APPLICATION NO.	FILING DATE	FIRST NAMED INVENTOR	ATTORNEY DOCKET NO.	CONFIRMATION NO.
09/687,600	10/12/2000	Jason E. Tripard	MI22-1550	2568
21567	7590 06/29/2004		EXAMINER	
WELLS ST. JOHN P.S.			CHOI, STEPHEN	
601 W. FIRST AVENUE, SUITE 1300 SPOKANE, WA 99201			ART UNIT	PAPER NUMBER
or ordinate,	VII		3724	
			DATE MAILED: 06/29/2004

Application No.	Applicant(s)	(_			
Office Action Summary		09/687,600	TRIPARD, JASON E.				
		Examiner	Art Unit				
		Stephen Choi	3724				
The MAILING DATE of this communication appears on the cover sheet with the correspondence address Period for Reply							
A SH THE - Exte after - If the - If NO - Failu Any	ORTENED STATUTORY PERIOD FOR REPLY MAILING DATE OF THIS COMMUNICATION. Insions of time may be available under the provisions of 37 CFR 1.13 SIX (6) MONTHS from the mailing date of this communication. It is period for reply specified above is less than thirty (30) days, a reply of period for reply is specified above, the maximum statutory period we are to reply within the set or extended period for reply will, by statute, reply received by the Office later than three months after the mailing ed patent term adjustment. See 37 CFR 1.704(b).	36(a). I

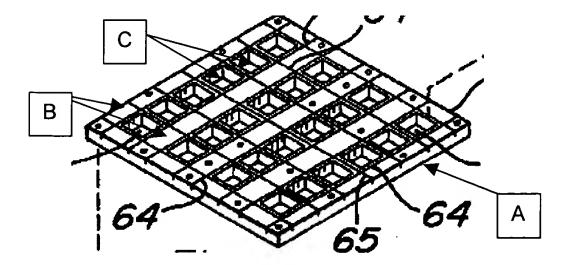
Neu discloses all the recited elements of the invention including:

- a) a panel having an uppermost surface and molded as part of the separator (A, Figure below);
- b) a plurality of blocks (B, Figure below) as one piece with the panel and extending upward from the uppermost surface of the panel creating a recessed portion (C, Figure below) on the panel;
- c) a cutting mechanism.

Applicant contends that Neu does not teach a plurality of blocks formed to extend upward from the uppermost surface of the element 62. Furthermore, Neu does not teach a recessed portion between the plurality of blocks and the uppermost surface of the panel.

The examiner respectfully disagrees. The figure above shows "a plurality of blocks" being formed as one piece with "a panel". The element A indicating a bottom portion of element 62 is designated as "a panel" wherein the element B designated as "a plurality of blocks" which extend upward from the uppermost surface of the element A. Hence, the recessed portion designated as the element C is formed by the element

B such that the recessed portion extend between the block upper surfaces (top surfaces of the element B) and the uppermost surface of the panel A.
